## JOINT REGIONAL PLANNING PANEL (Sydney East Region)

<b>JRPP No</b>	2013SYE002
<b>DA Number</b>	LDA2012/0471
<b>Local Government Area</b>	City of Ryde
<b>Proposed Development</b>	Construction of a residential flat building consisting of 91 apartments, 16 semi-detached dwellings, construction of internal Road 5 and associated landscaping and public domain works (known as Stage 1 Phase 4a + Phase 2H)
<b>Street Address</b>	600 Victoria Road, Ryde
<b>Applicant/Owner</b>	Frasers Putney Pty Ltd
<b>Number of Submissions</b>	4 during the original notification period. 1 during the second notification period.
<b>Recommendation</b>	Approval with Conditions
<b>Report by</b>	Holly Palmer, City Plan Strategy & Development on behalf of City of Ryde

### Assessment Report and Recommendation

Figure 8. Extract of the Level 1 Plan demonstrating that appropriate lines of sight are achieved to the lobby and lift core area of the RFB.

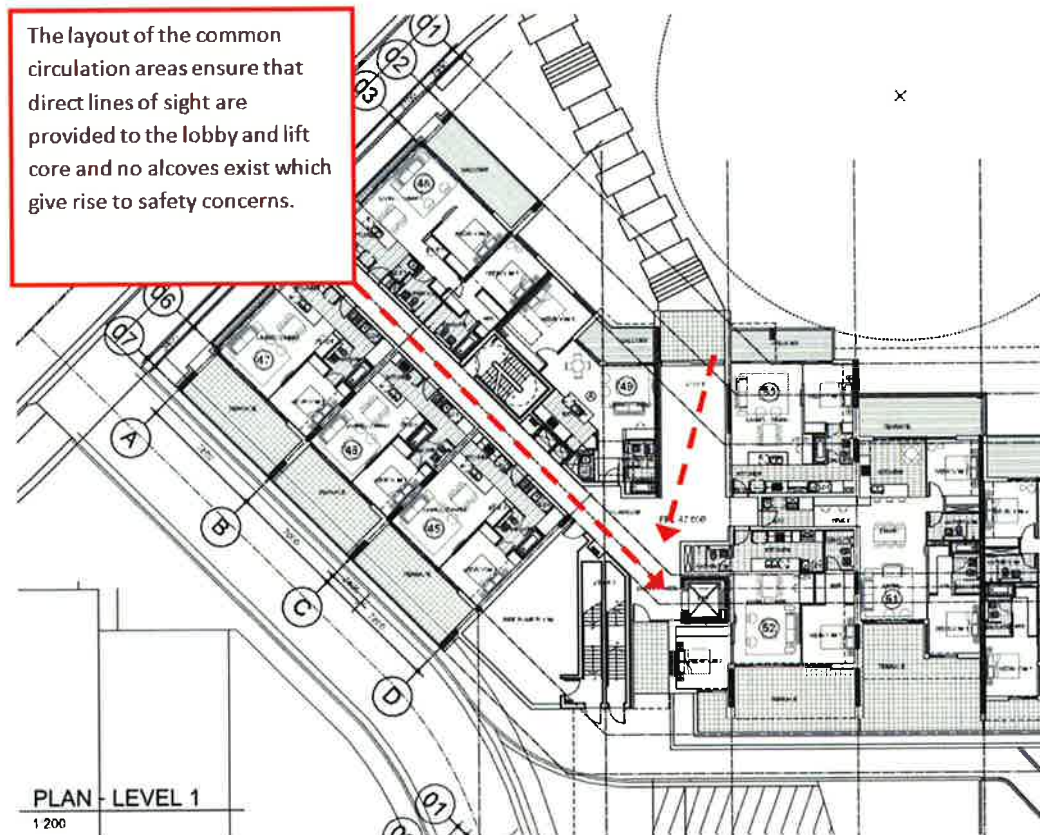
"Council's City Urban Designer Officer has suggested some minor amendments to the layout of the apartment building to improve the internal amenity. Cox Richardson has noted this advice and has amended the design of the building to provide a direct line of sight from the south west corridor to the lift lobby. Due to the orientation of the building, which has been determined based on the sites constraints and opportunities, it is significantly difficult to provide a direct sight line between the building entry and the lift cores."

The layout of the lobby areas to the lift cores achieve a suitable circulation area which achieves appropriate lines of sight and avoids alcove areas which pose as possible safety concerns, as demonstrated in Figure 8 below. The layout of the lobby and lift core areas is supported.

Figure 11. Plans of Level 5 and 6 of the RFB identifying the location of the two temporary sales and marketing suites (highlighted in green)

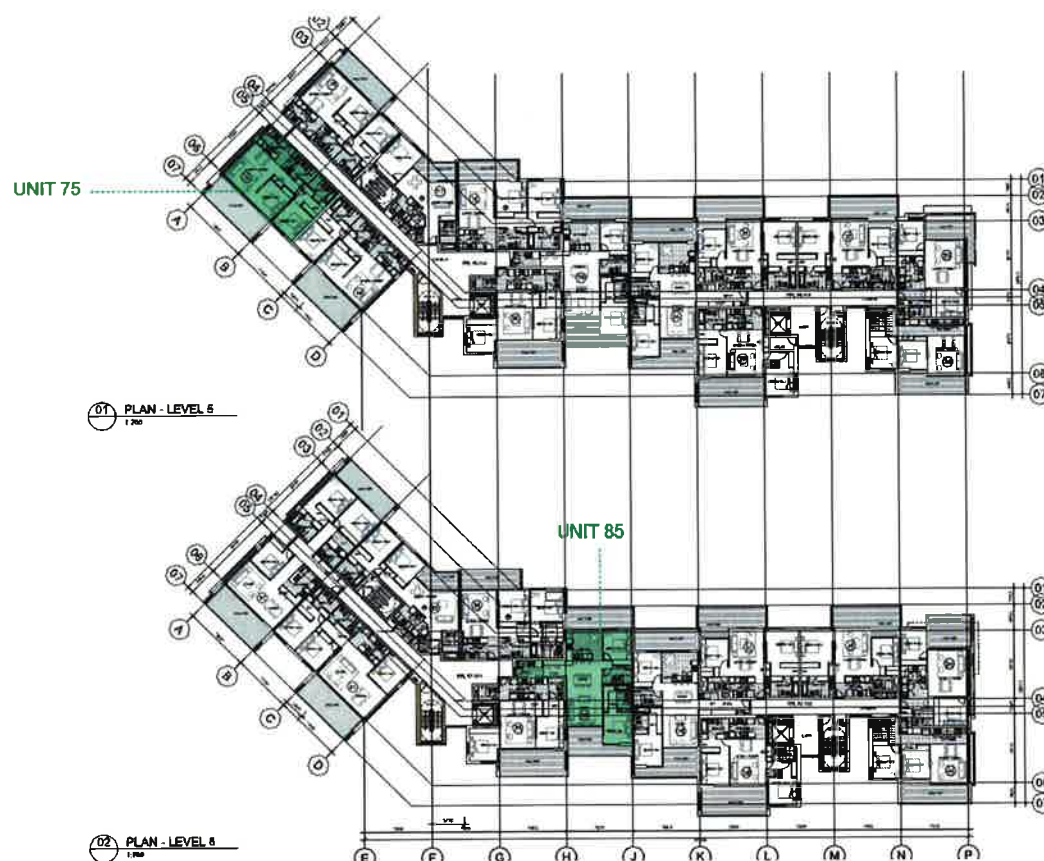
The proposal seeks approval for the occupation and fitout of Unit 75 on Level 5 and Unit 85 on Level 6 within the residential flat building (RFB) 4A for the purpose of a temporary sales and marketing suite and display units. The location of the selected units is identified in the Figure below: -

Figure 16: Extract of the Apartment Section Plan showing the apartment building (left), and neighbouring residential dwellings (right), which have a minimum separation distance of 31m to the SE property boundary across the public park.

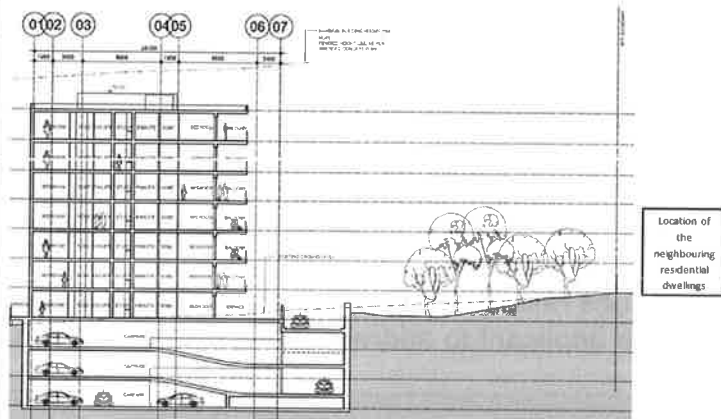
When considered in light of the apartment building, the amenity of the neighbouring properties is protected by the boundary fencing which is 1.8m in height, a minimum distance of 31m across the public park to the southern boundary, screen planting and landscaping. This relationship is depicted in the Figure below.

Figure 20: Extract of the Landscape Plan demonstrating the landscape screening and tree planting along the side boundary.

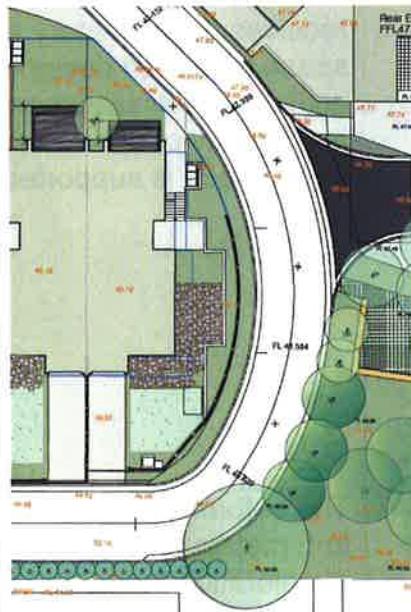
Furthermore, landscape screening and a tree are proposed along this boundary to assist in mitigating the potential impact of headlights (refer to Figure below).

The boundary fencing and landscaping are considered appropriate in protecting the amenity of the adjoining dwellings with regard to potential light impacts. In addition, it is noted that this road will service occupants and guests of the row houses only, and is not anticipated to generate a high level of traffic.
